Access Consulting  
 Building Compliance  
 Ref: AN019-213829 44-45 Tench Ave Jamisontown  
 Reviewed by: Lucy Alderson  
 Date: 11/12/2019

PROJECT  
 ORANGE FIELDS

CLIENT	MKT CAFE PTY LTD	SCALE	SHOWN@A2	JOB NO.	0461
ADDRESS	44-50 TENCH AVE JAMISONTOWN NSW	DATE	27.09.19	DRAWN	MW
DRAWING NAME	PROPOSED SITE PLAN	DRAWING NO.	02	ISSUE	D

**1** DETAIL PLAN  
SCALE 1:200 @ A2

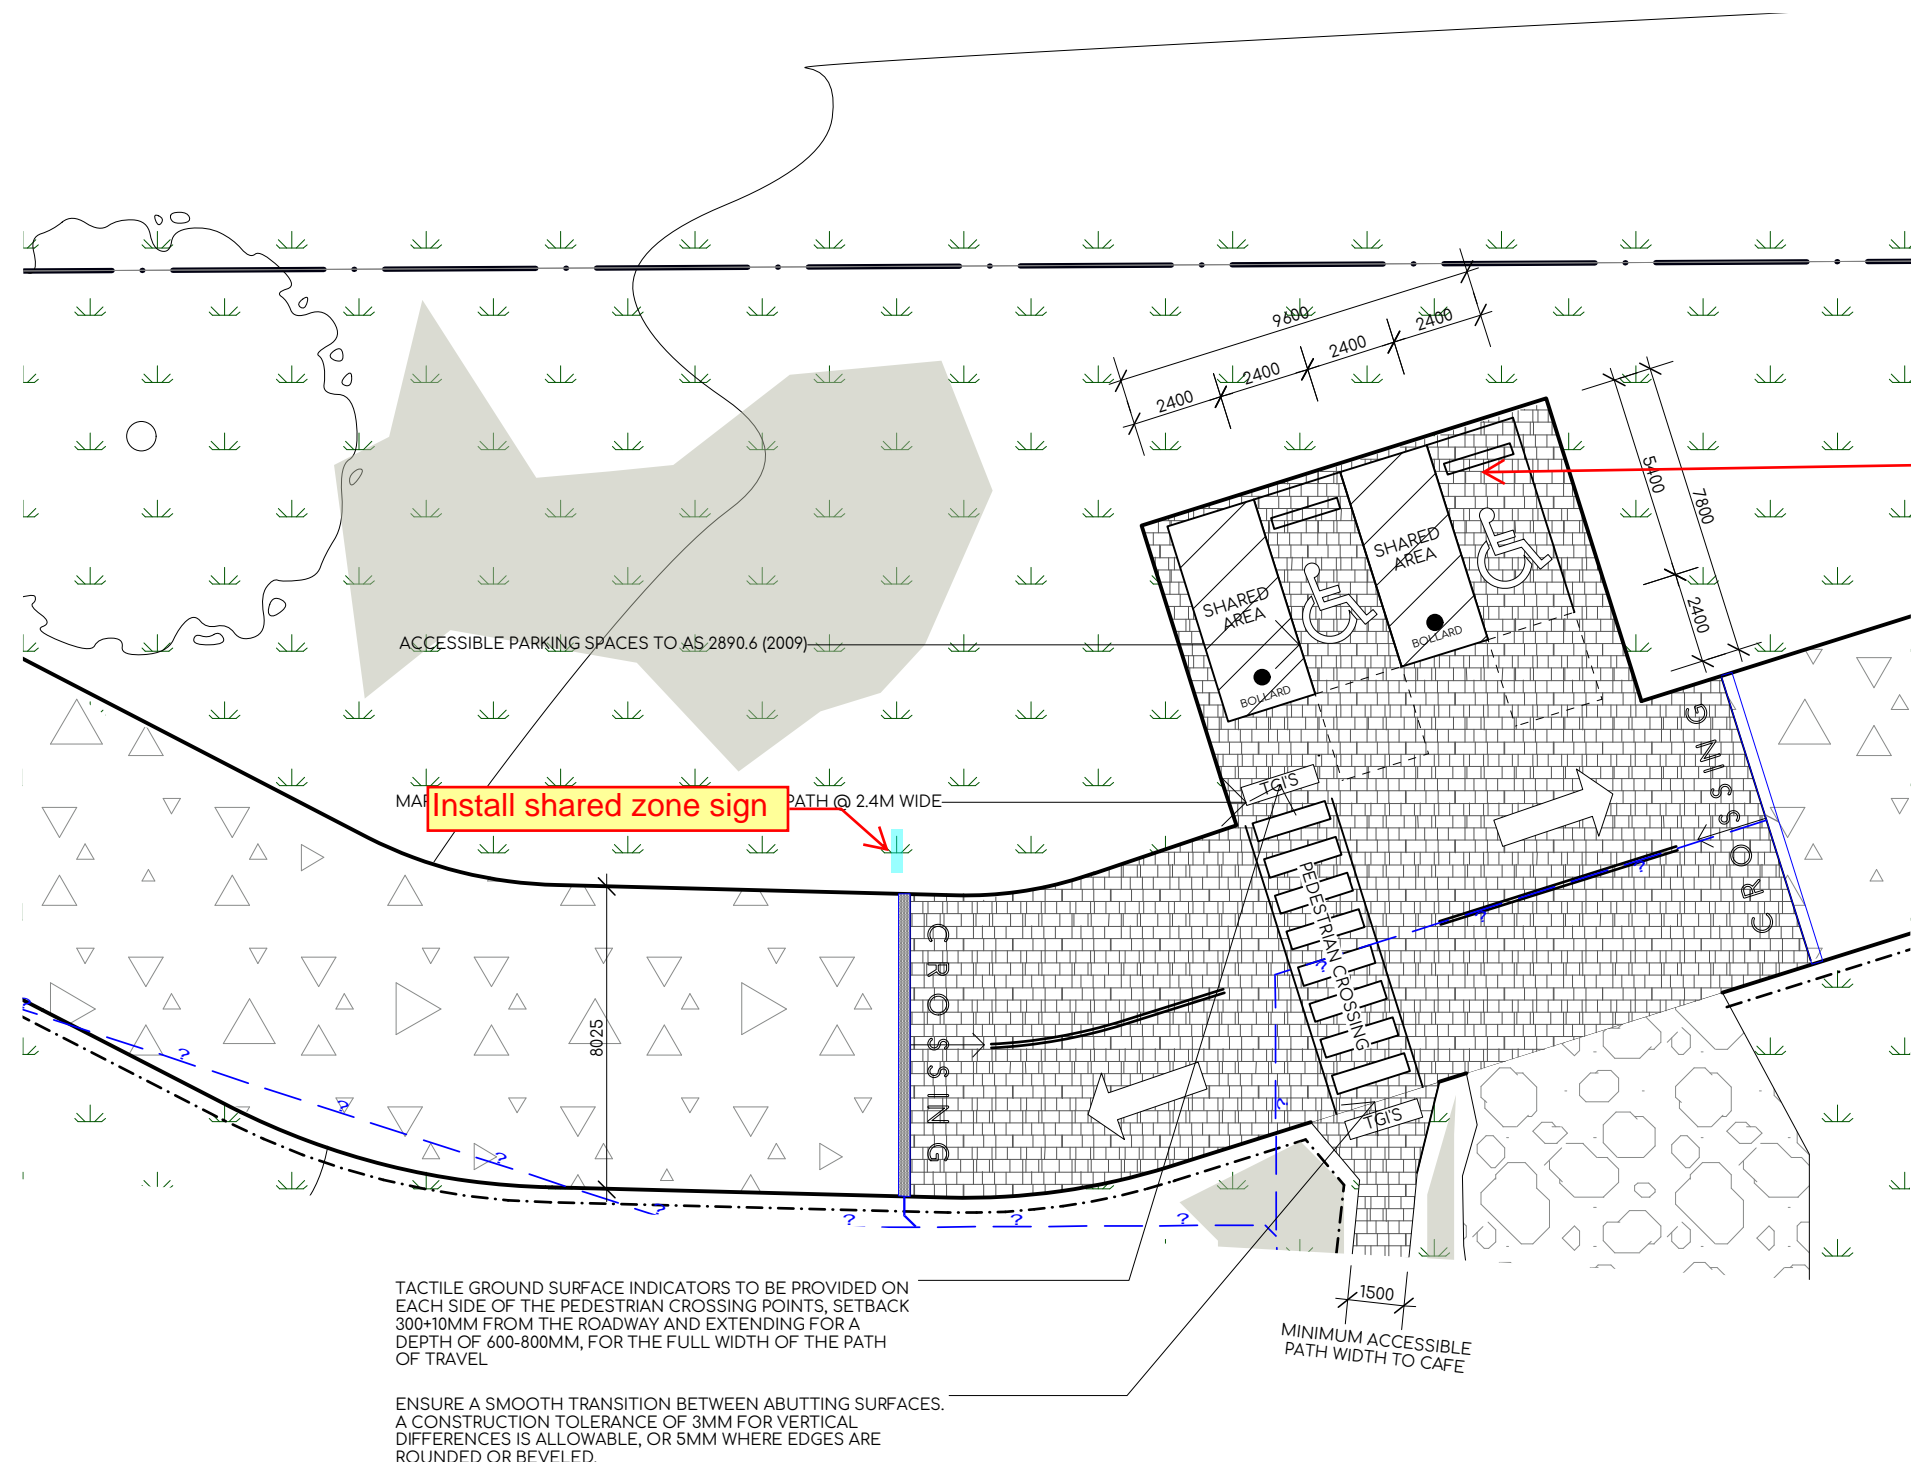
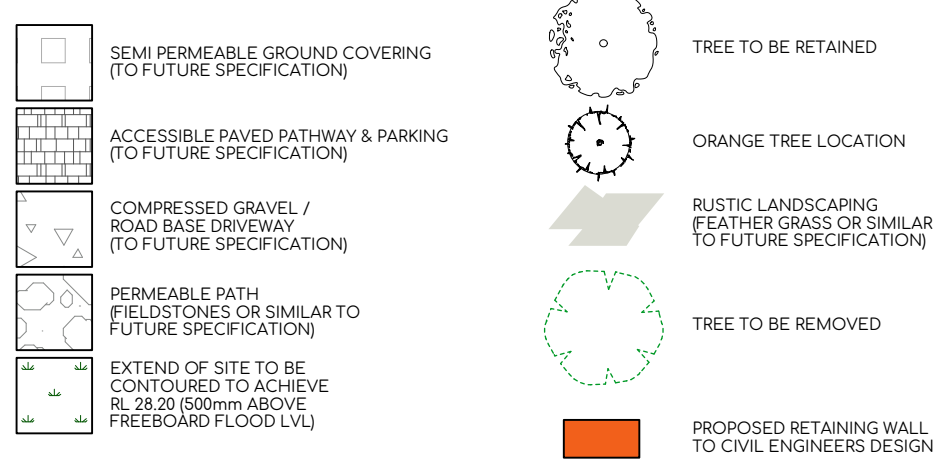
**Accessible car parking - AS 2890.6 (2009)**

Ensure the final design complies with all elements of AS 2890.6 (2009) including but not limited to:

- Minimum dimensions of dedicated and shared area;
- pavement slope and surface;
- kerb ramps where required;
- bollard installation;
- head room;
- space identification;
- space delineation.

We recommend bollards be a height of 1300mm to ensure reversing drivers can see the bollard above the rear of their vehicle (AS 2890.6 (2009), Clause 2.2.1(d)). Furthermore, consider selecting a finish with a luminance contrast of minimum 30% against the background surface to which it is viewed (i.e. car park floor surface).

During subsequent detailed design development stages provide detailed documentation.

1 DETAIL PLAN  
 SCALE 1:100 @ A2

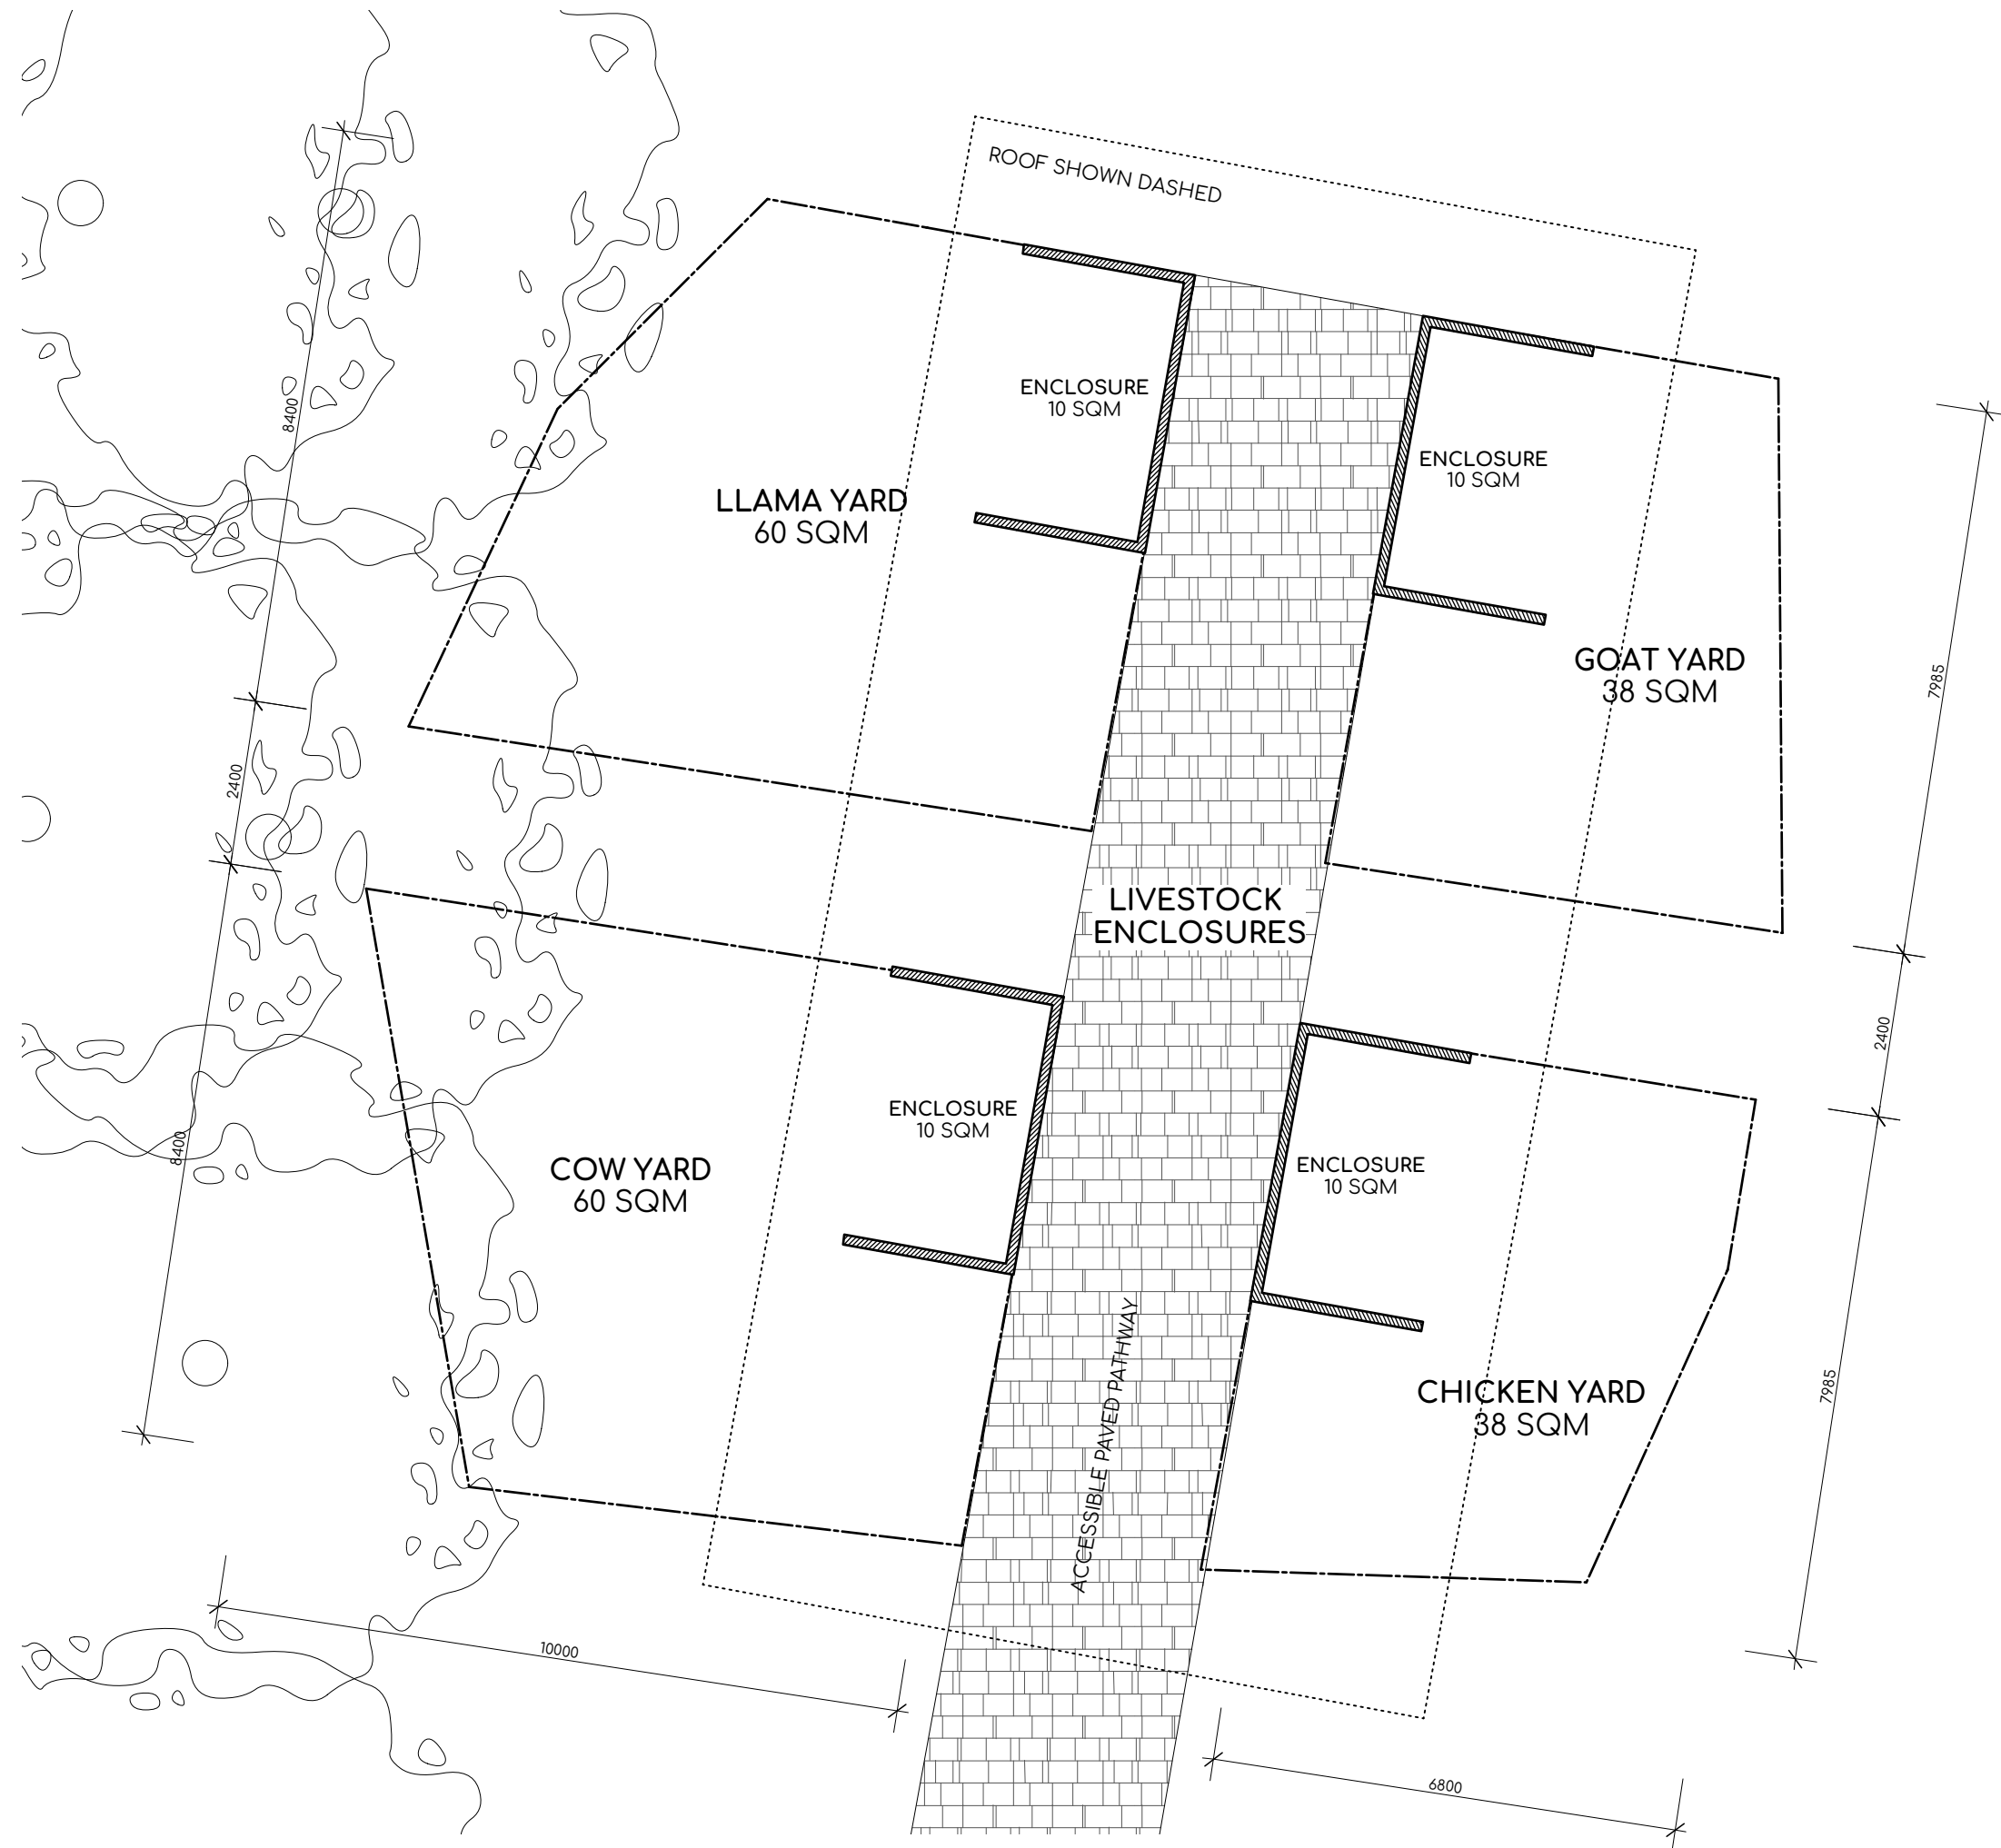
Ensure a continuous accessible path of travel has been provided to all buildings required to be accessible from:

- The main points of pedestrian entry at the allotment boundary; and
- From another accessible building connected by a pedestrian link; and
- From any required accessible car parking space on the allotment. (BCA Clause D3.2)

During subsequent detailed design development stages provide a survey showing proposed RLs for all external linkages within the site boundary for a comprehensive assessment/detailed coordination to comply with BCA D3.2.
